**Project #:** EBOS-0027

December 6, 2019

**Subject:** 93-95 Prescott Street, East Boston, MA  
Revised Notice of Intent Application

**PERMIT SET - SITE PLAN**  
 93-95 PRESCOTT STREET, EAST BOSTON, MA

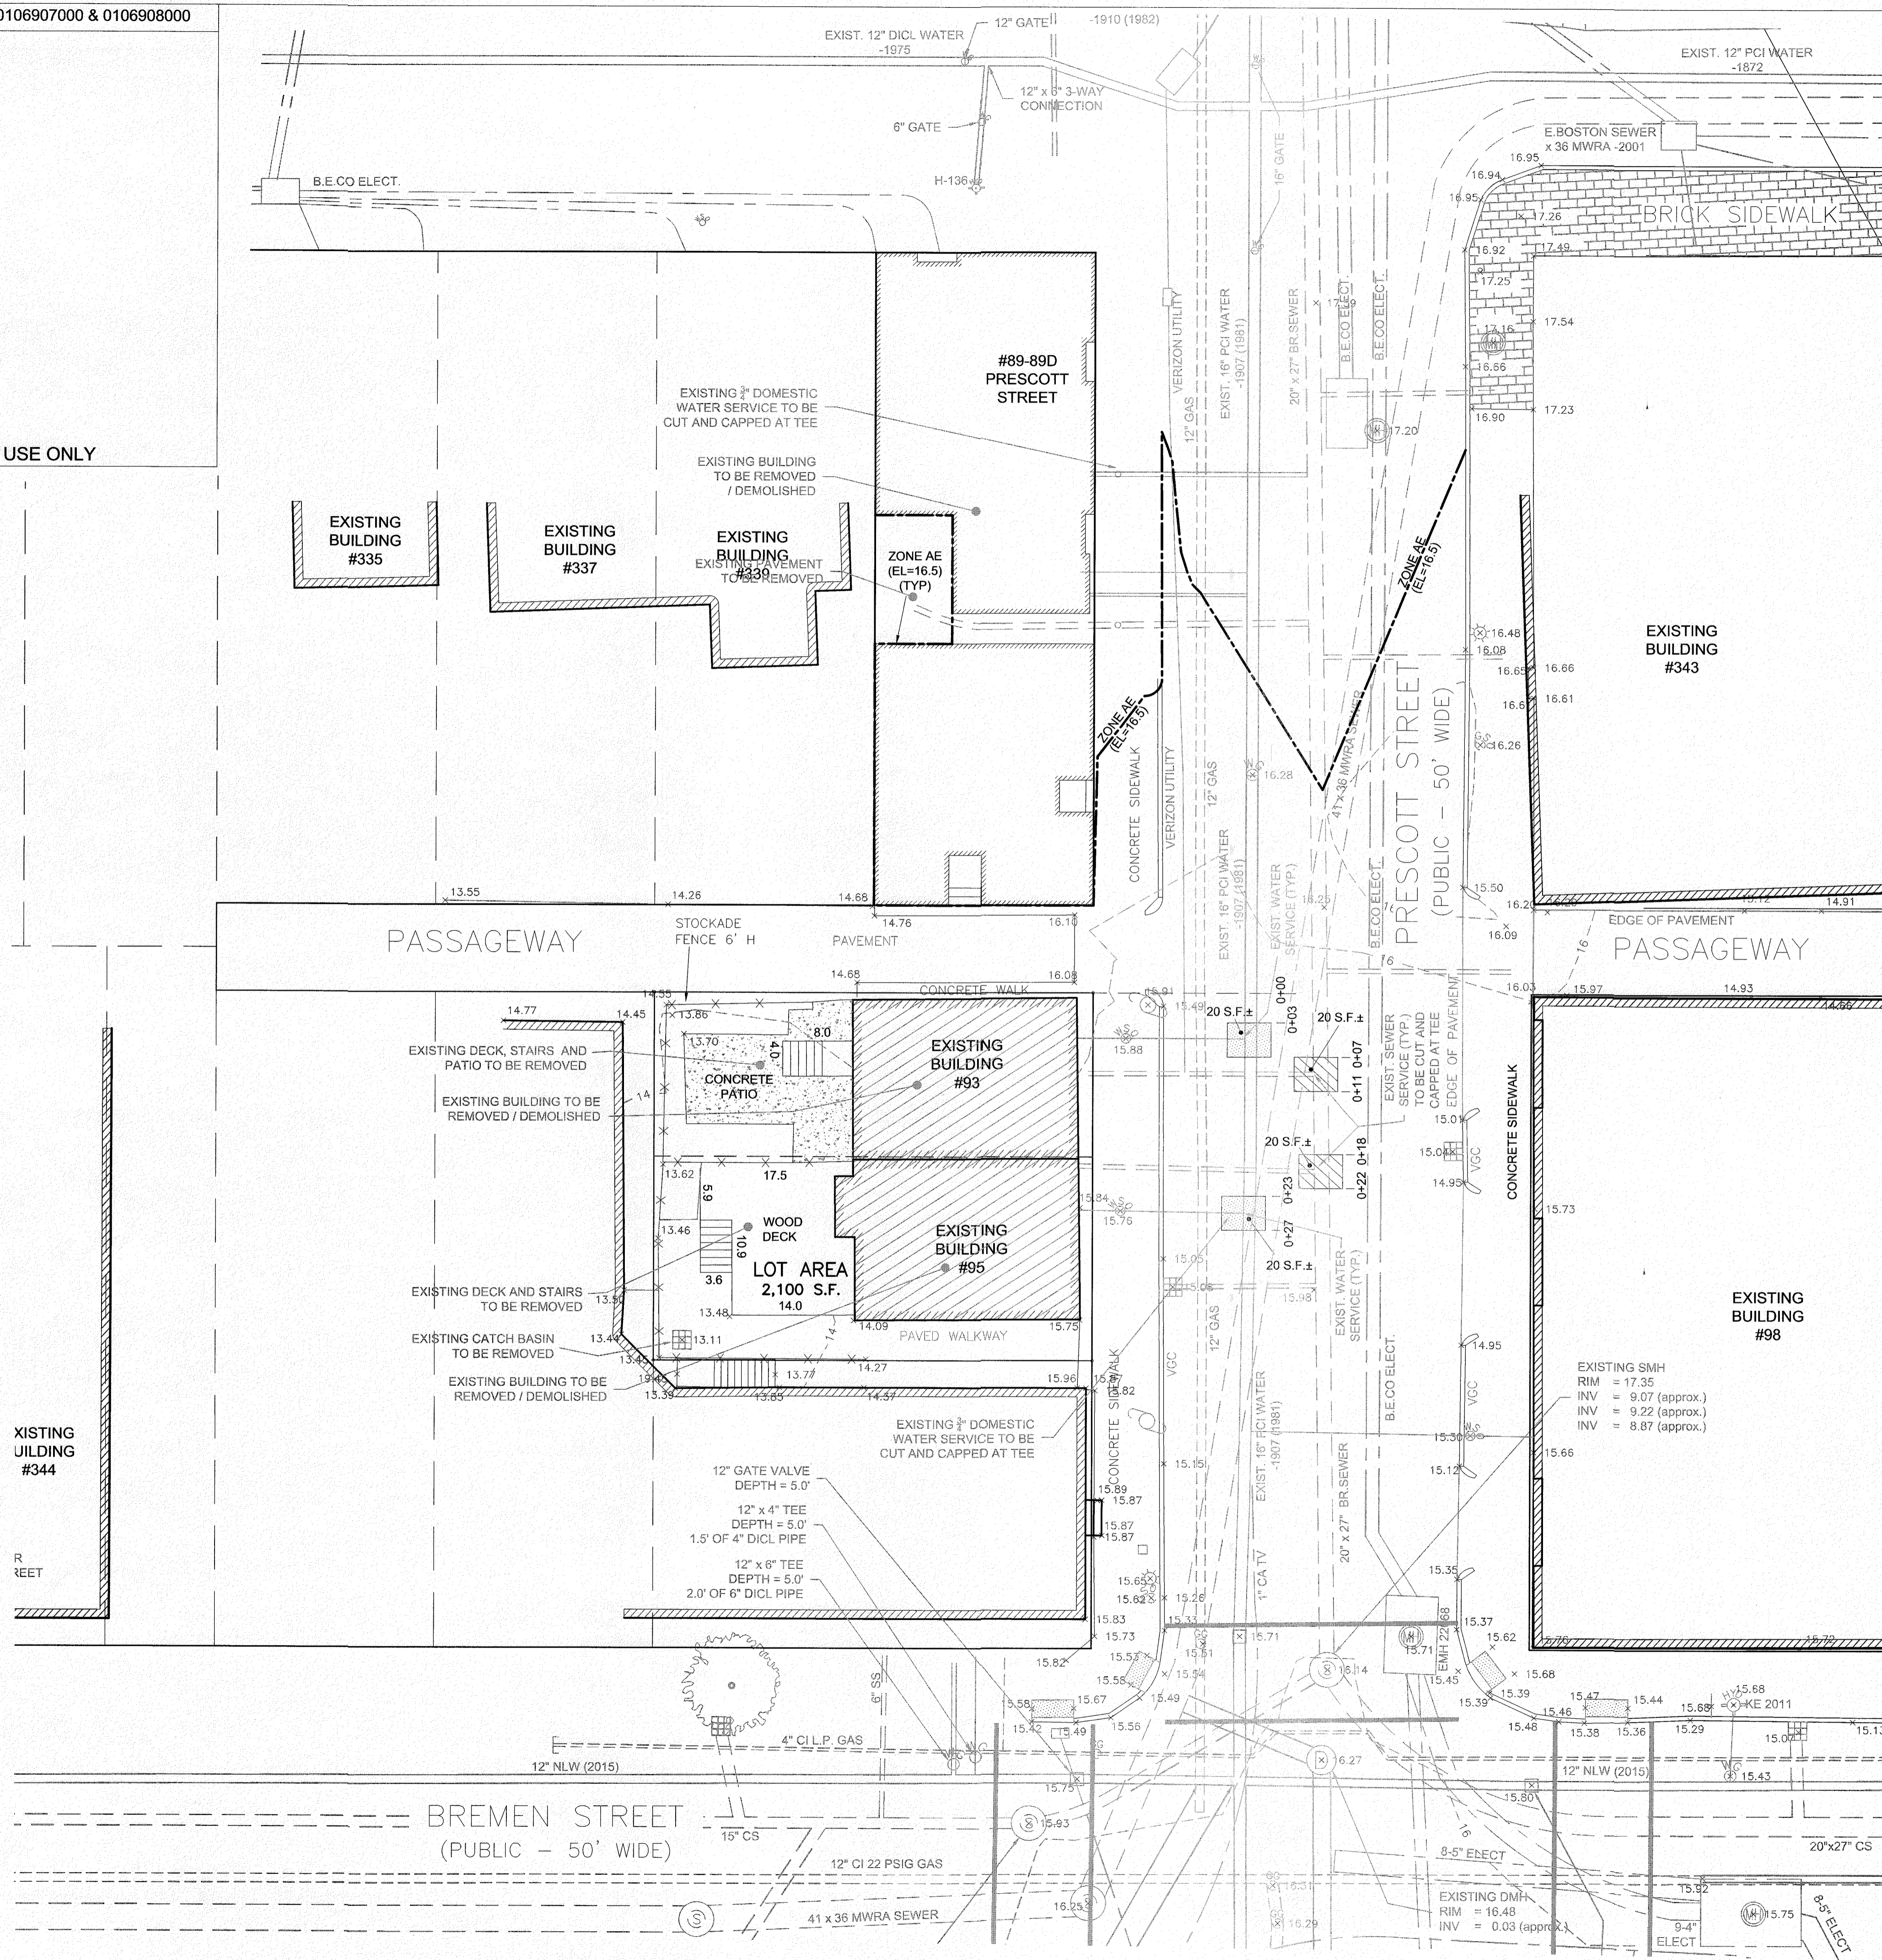
- Not all of the elevations listed on the climate resiliency checklist are shown on the plan set. Additionally, we will need the resource area delineated on all sheets. We will need two hard copies of a new stamped plan set.

Elevations listed on the climate resiliency checklist are now shown on the plan set. Additionally, the limit of Land Subject to Coastal Storm Flowage has been added to the plan set. The entire parcel is within Land Subject to Coastal Storm Flowage.

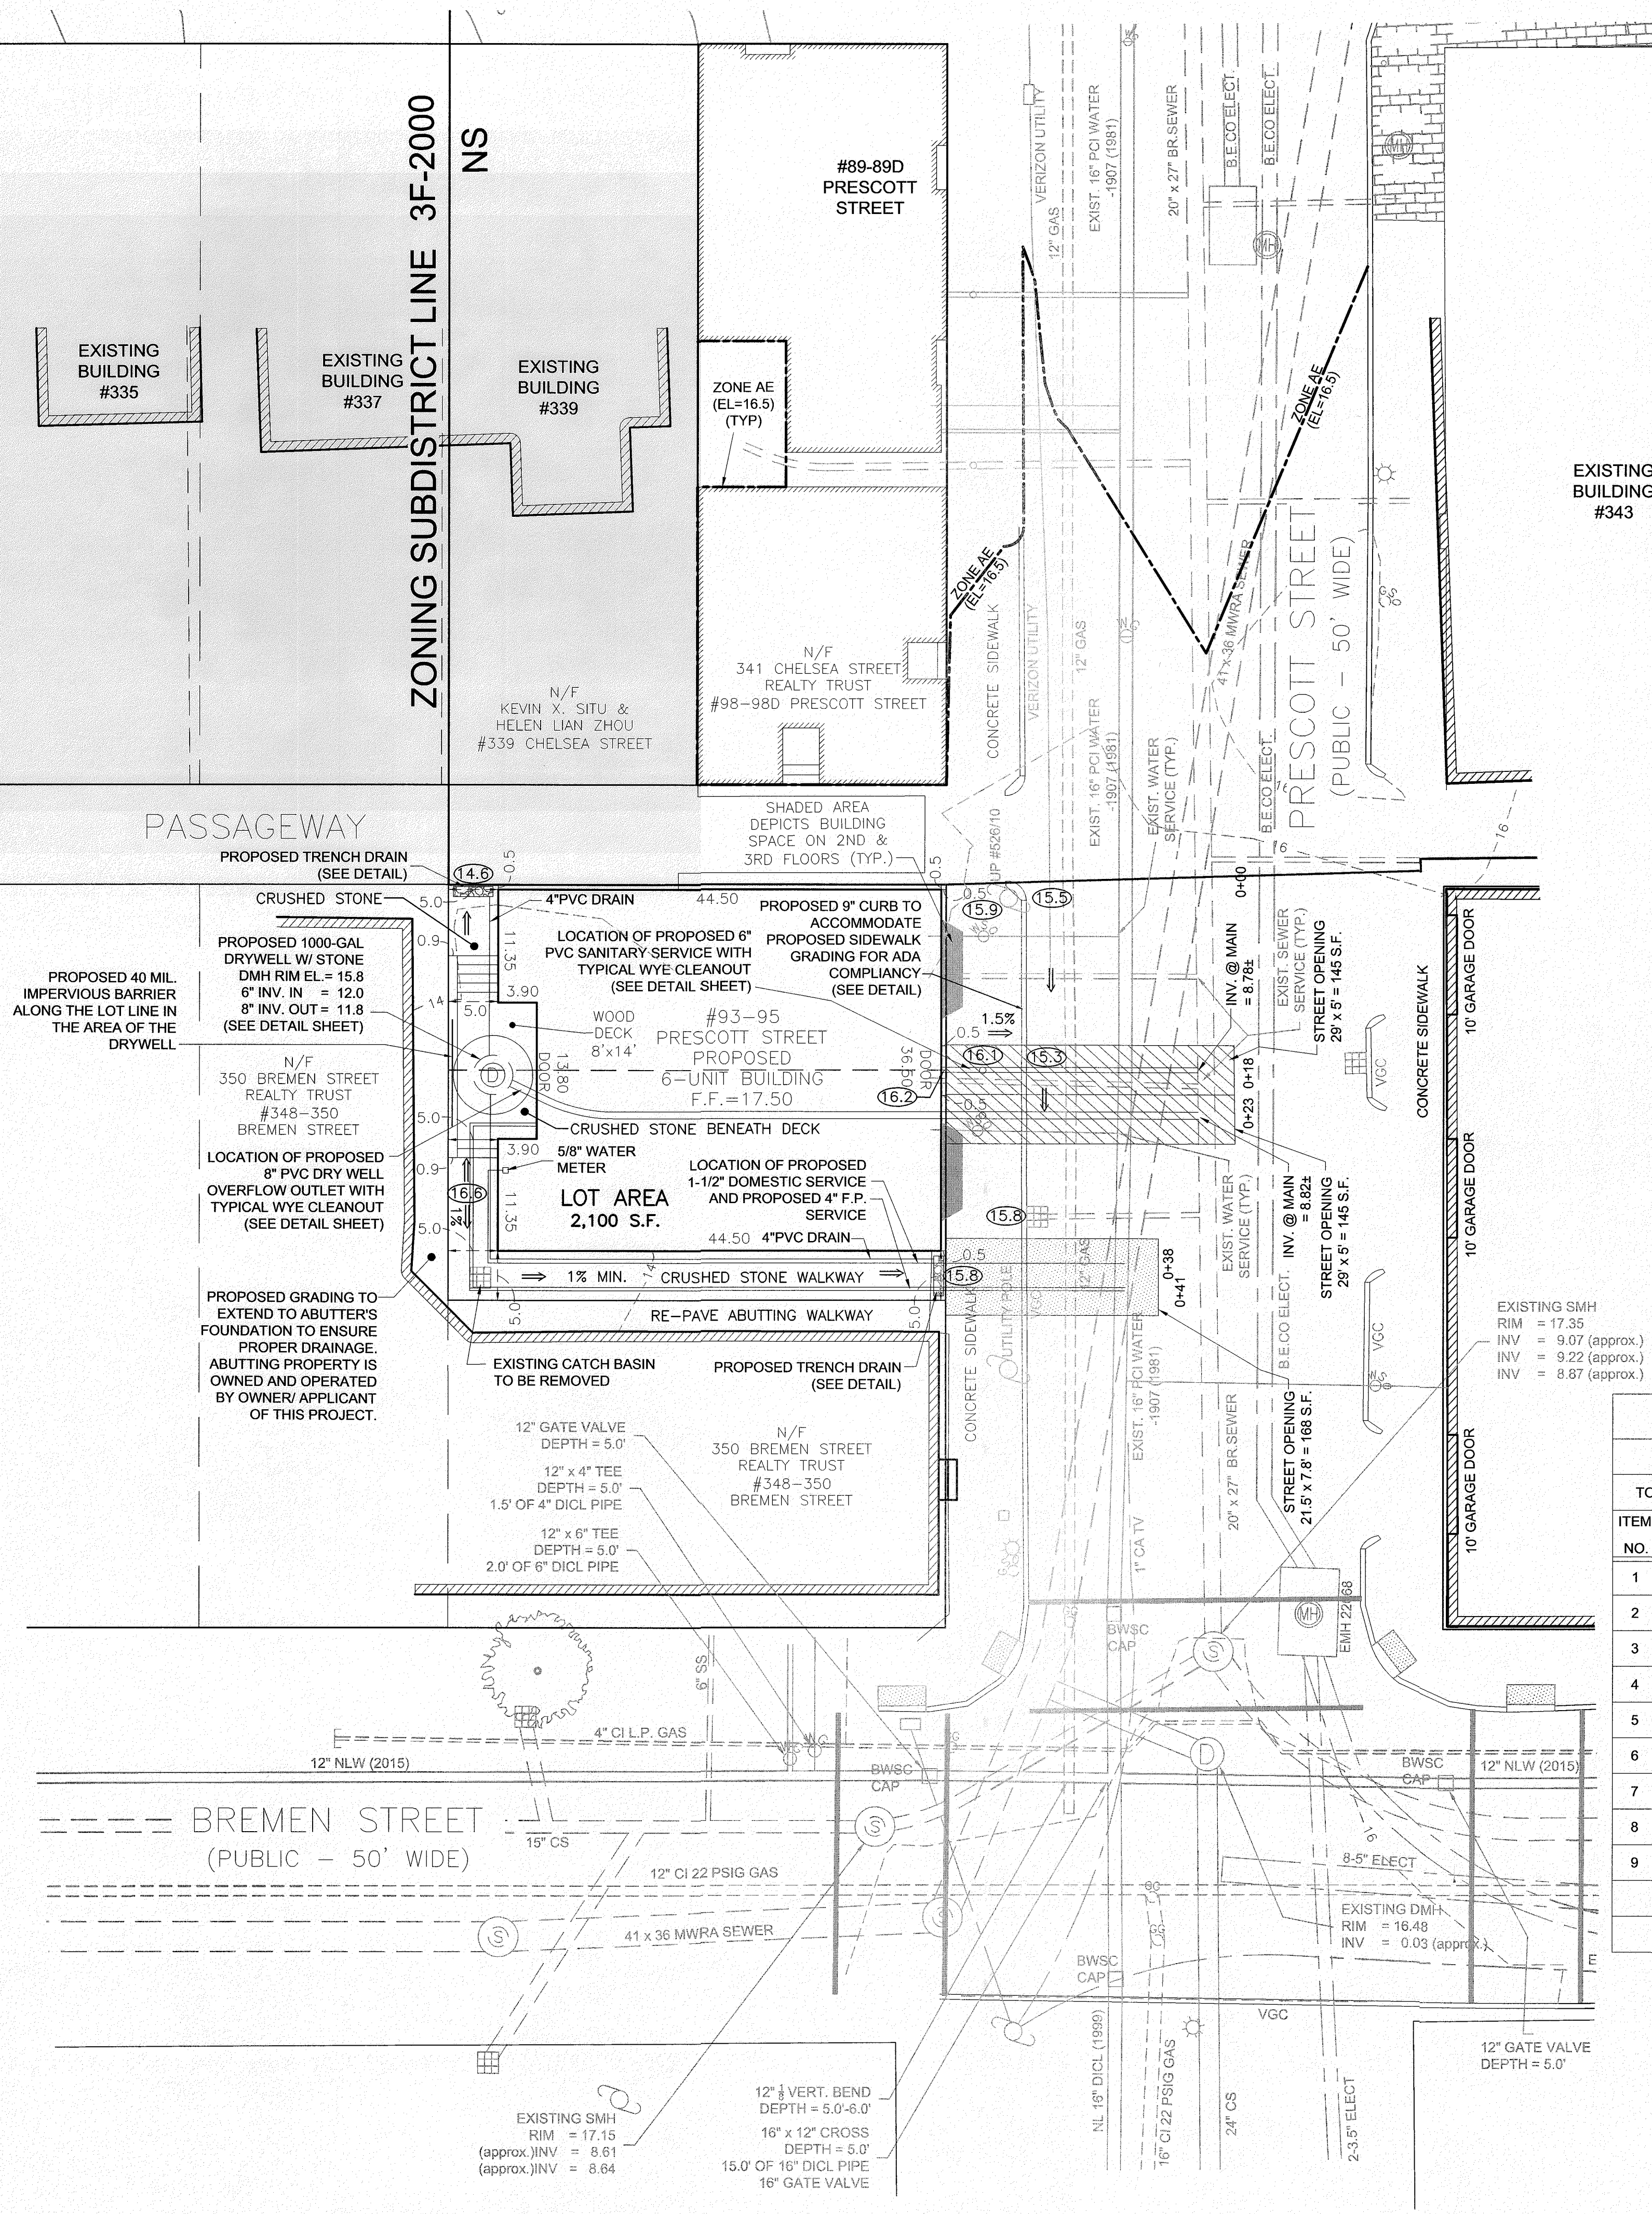
- In your narrative, you indicate that you are removing a private catch basin. Are you allowing runoff to be directed to the sidewalk/street?

Yes, runoff will now be directed towards Prescott Street and to the passageway off Prescott Street. A trench drain has been added to both sides of the project.
